2023/PDP-1 (MAK)

SUBJECT: Application for an Interim Planned Development-Transit
(IPD-T) Permit - File No. 2023/PDP-1
Project: Chinatown Hotel Development
Landowners: Yee Hop Realty Limited, and
C.Q. Yee Hop & Company Limited
Applicant: Ikenakea Hokele LLC
Agent: Patrick Seguirant
Location: 128 North Nimitz Highway - Chinatown
Tax Map Keys: 1-7-002: 013, 023, and 050
Acceptance Date: October 26, 2023

DEPARTMENT OF PLANNING AND PERMITTING
OF THE CITY AND COUNTY OF HONOLULU

EXHIBIT C-5

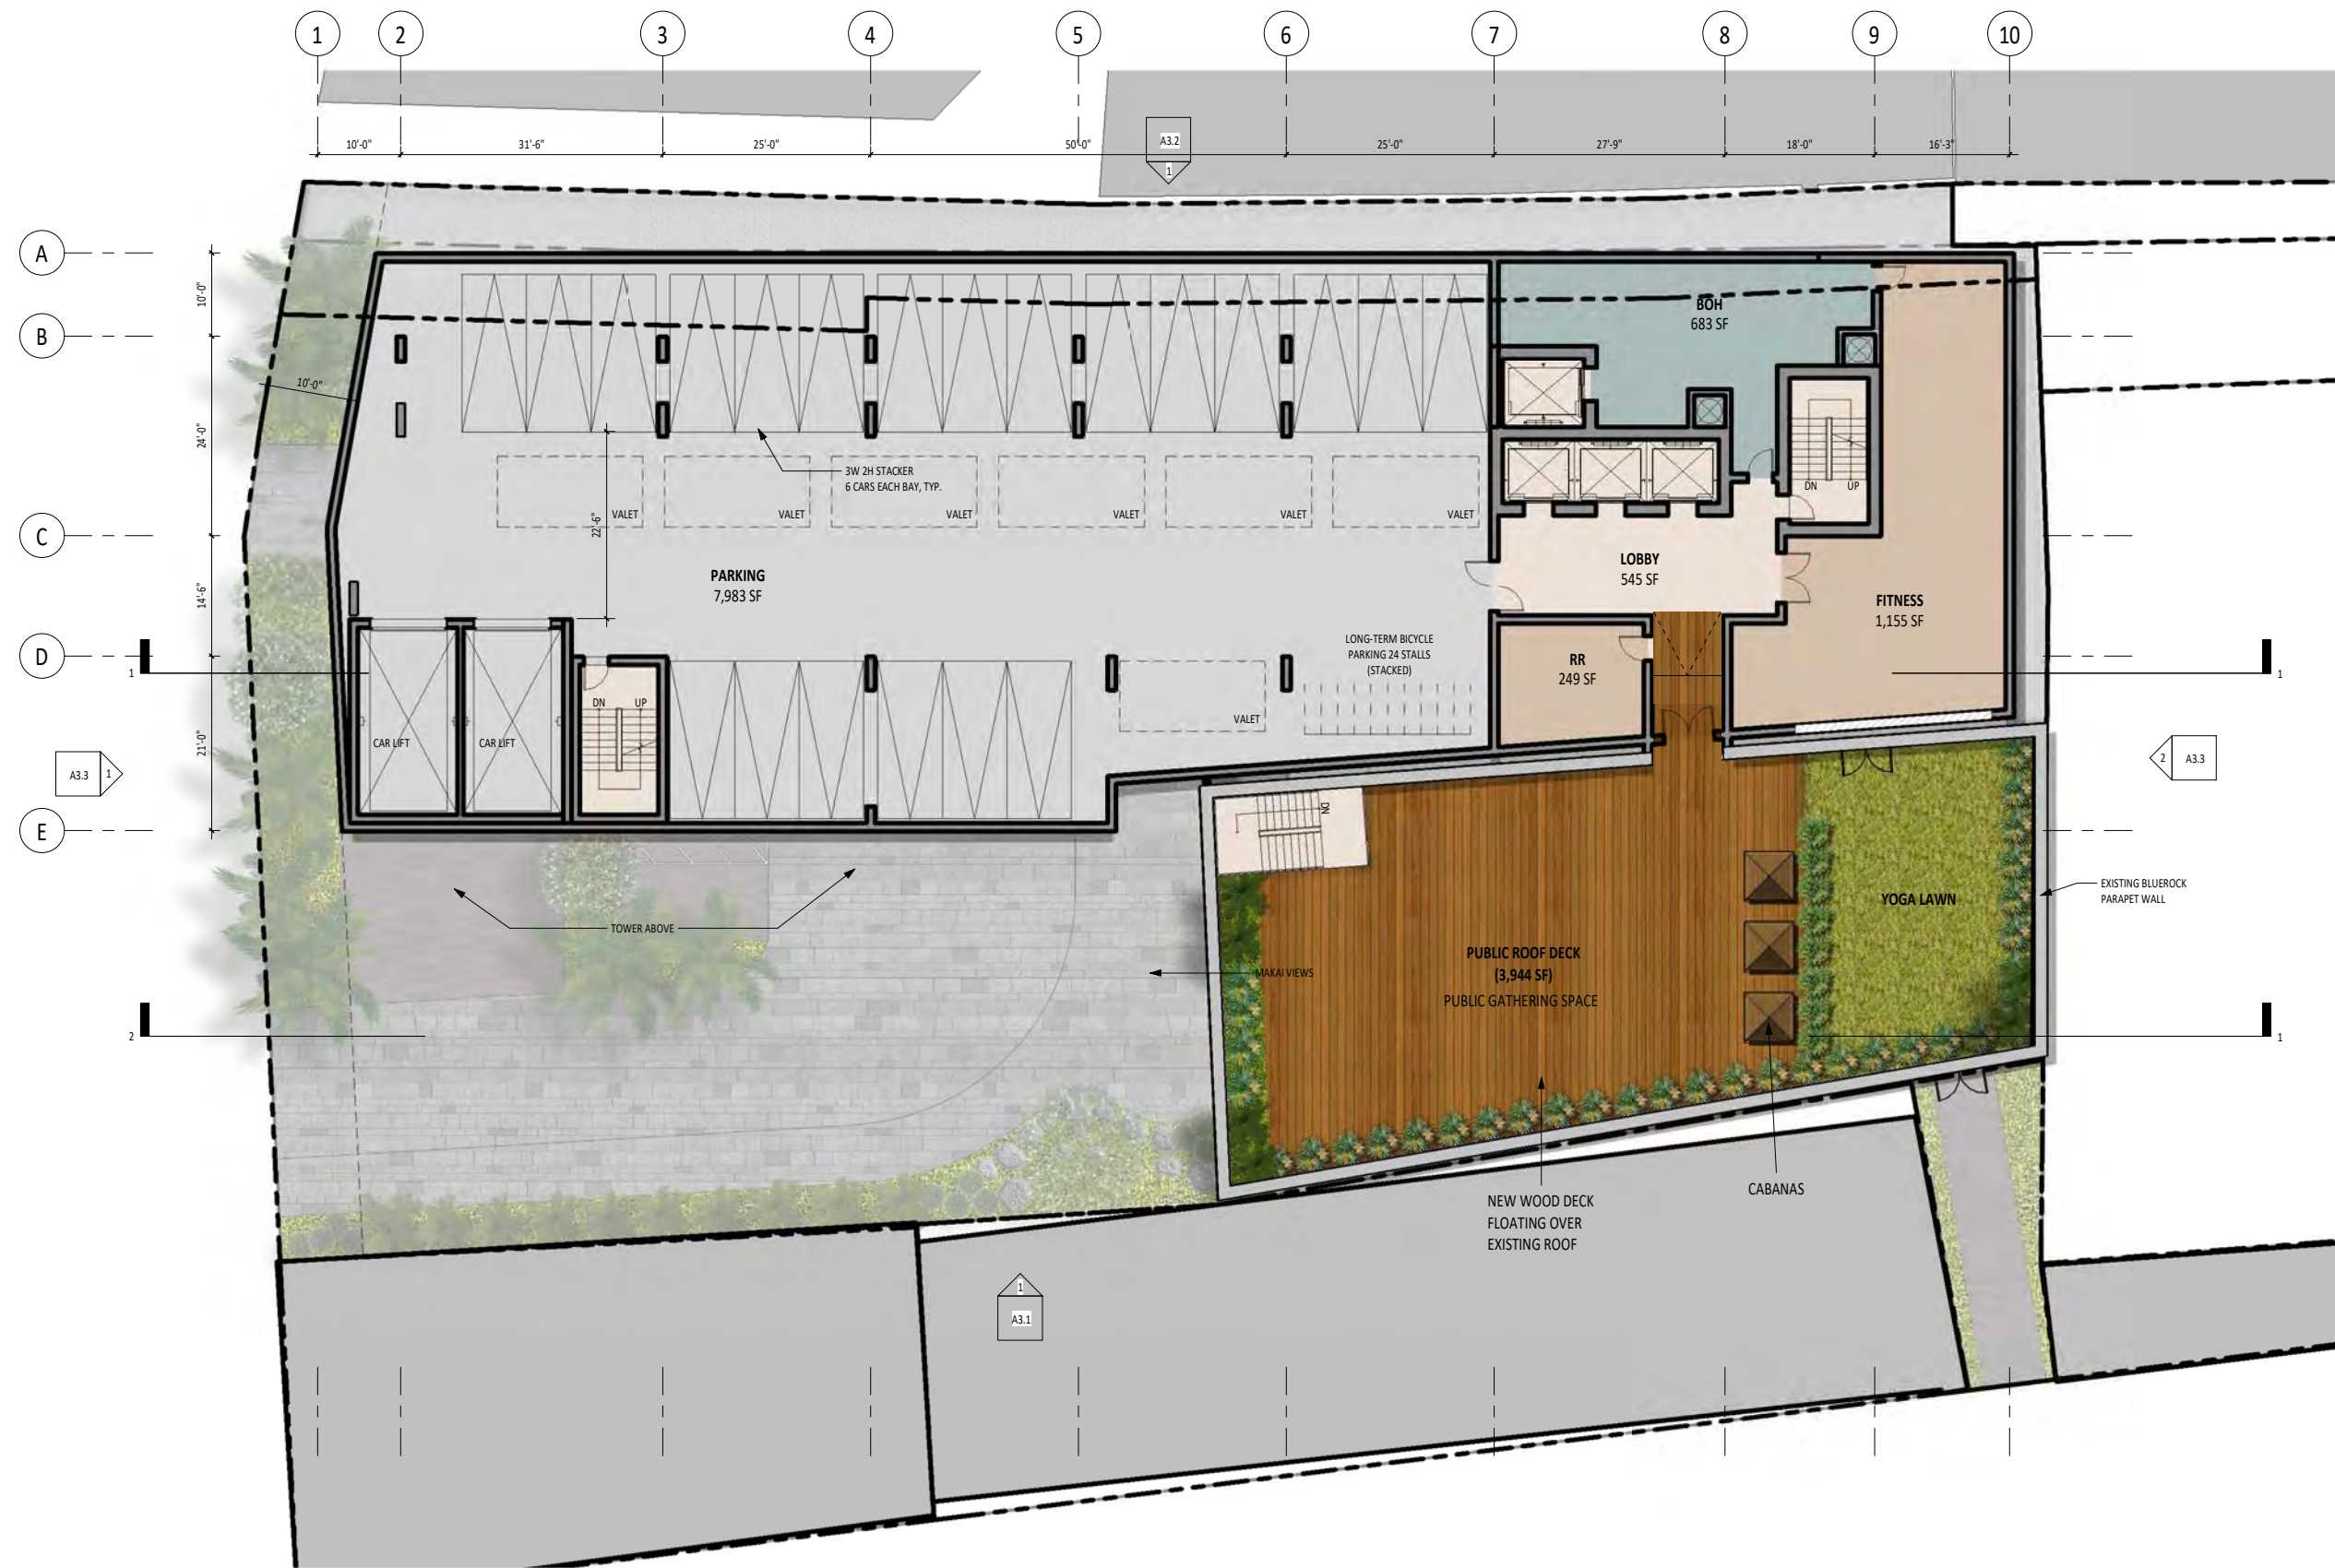
As previously mentioned, the ground floor plan under the porte-cochere is not pedestrian oriented. As proposed, pedestrians would either have to travel down Gravier Lane and cross through the loading bay or walk down the driveway against vehicle traffic. As the future guests of the hotel will likely be carrying luggage and have different walking needs, the orientation of the ground floor should be designed with higher priority given to pedestrian traffic traveling to the site from the north along Nimitz Highway. This is recommended as a condition of approval.

- H. The application for the Major SD Permit must include updated plans and documents showing the following:
1. Ground floor design and layout that minimizes conflicts between pedestrians and loading vehicles, especially along Nimitz Highway and Gravier Lane, through the use of signage, marked pedestrian paths, lighting, or safety infrastructure;
